Notice of Allowability

10/660,894

Frederick C. Nicolas

EXAMINER'S AMENDMENT

FIG. 1

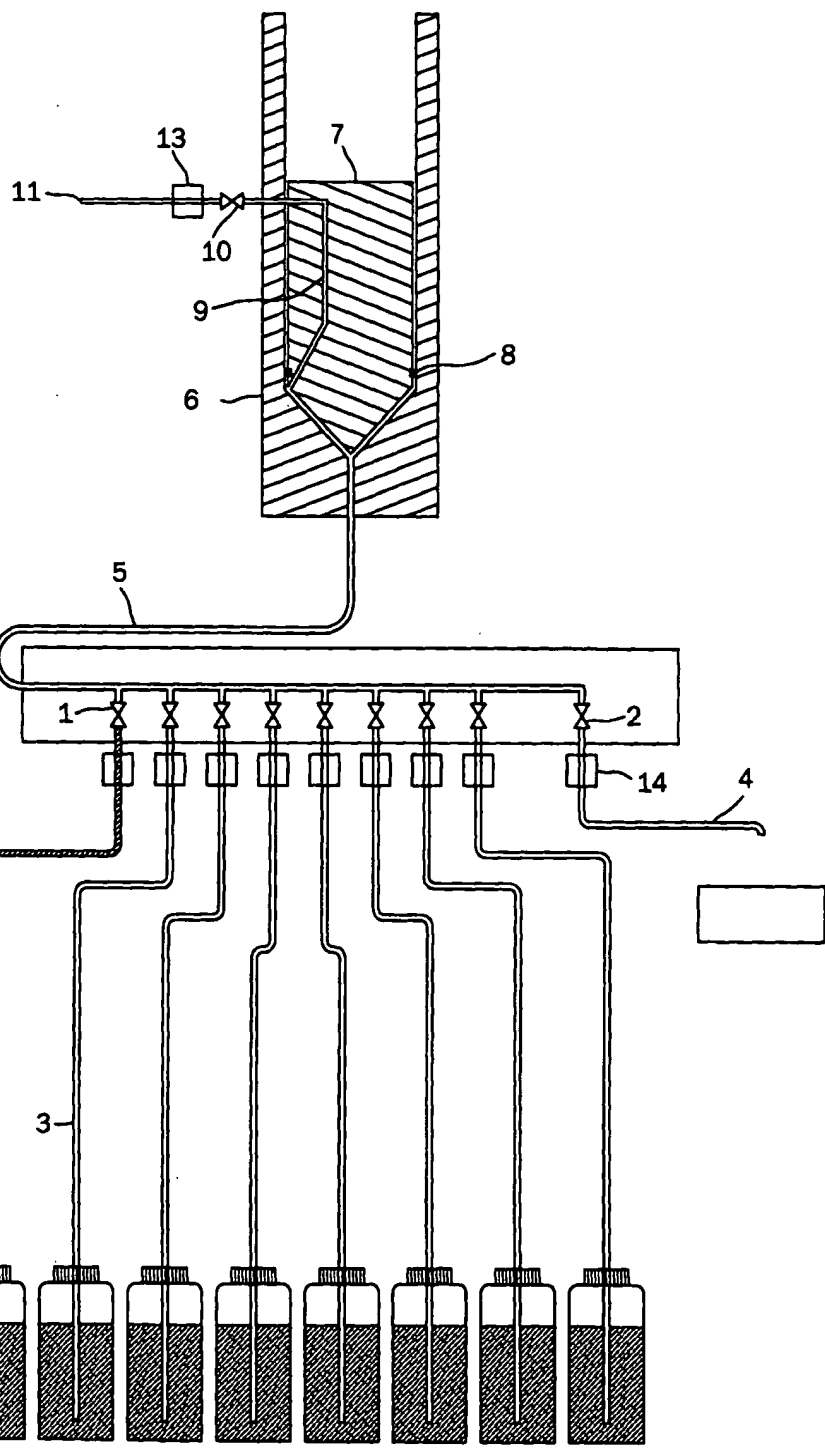
The following changes to the drawings have been approved by the examiner and agreed upon by applicant: in Figure 1, "containers" have been labeled as --15--, as per the attached drawing. In order to avoid abandonment of the application, applicant must make these above agreed upon drawing changes.
